### REMARKS

In the Office Action mailed August 31, 2006, firstly, Examiner objected to the drawings indicating that Figure 10 required correction to substitute --13-13-- for "B-B", and noting that reference numerals 46 and 18 were missing from the drawings. The drawings have now been amended to correct those deficiencies.

Fig 4

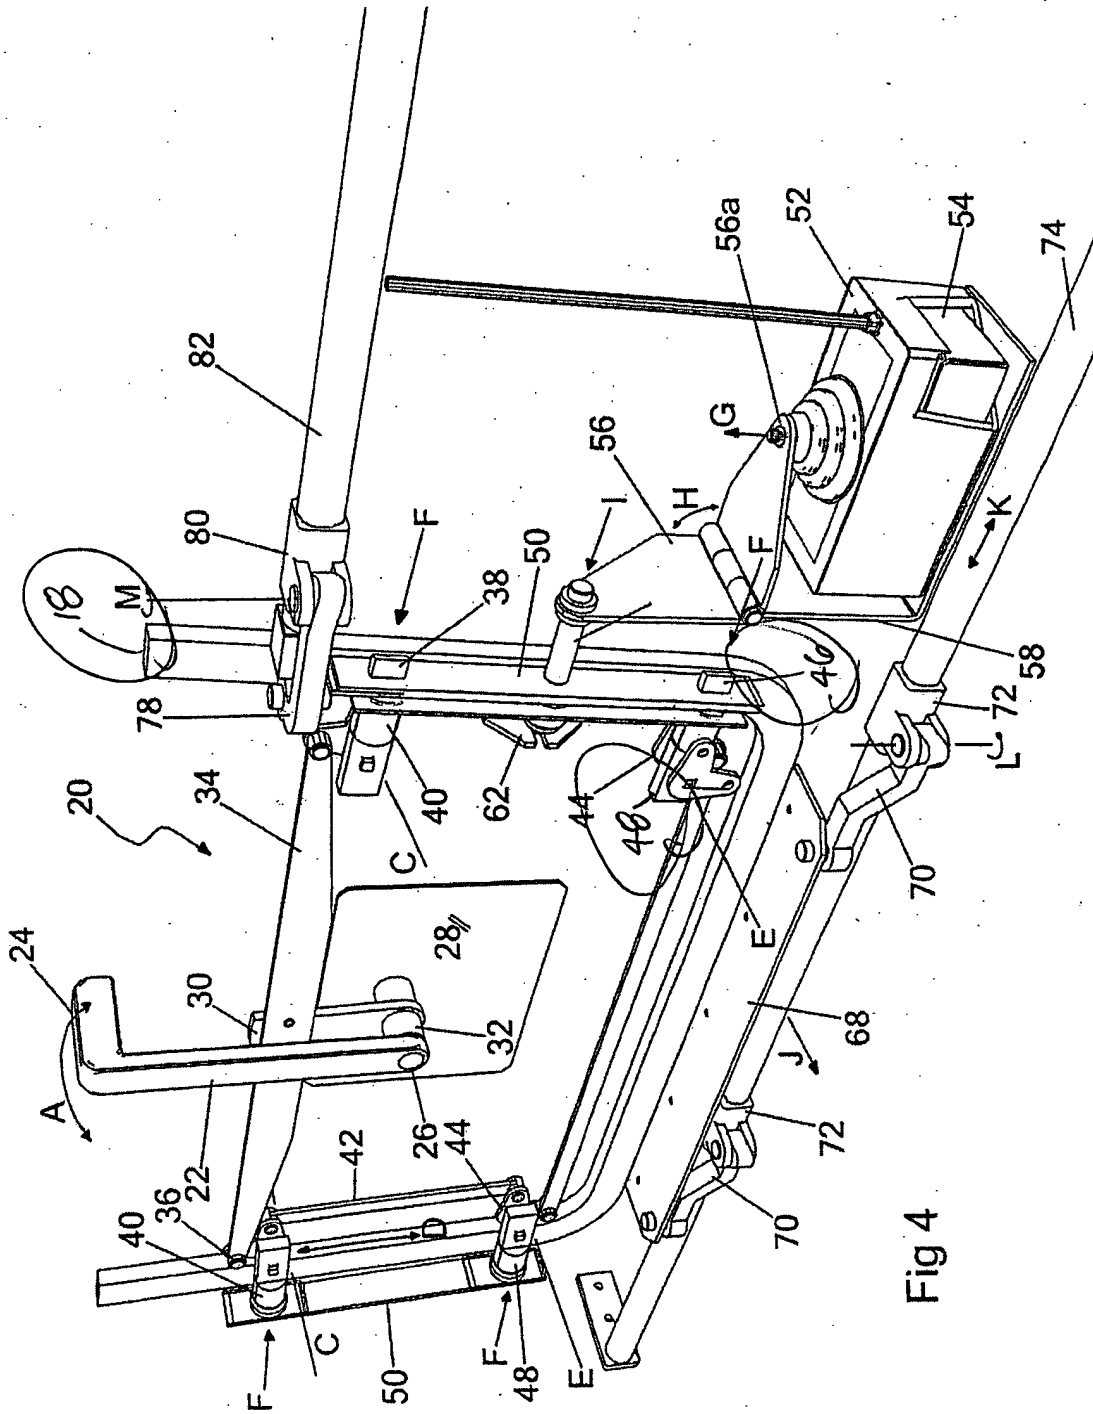
Applicant submits proposed changes to Figures 1, 3, 4 and 10, shown as circled. Applicant requests that the Examiner consider the changes. A complete set of drawings is enclosed as required.
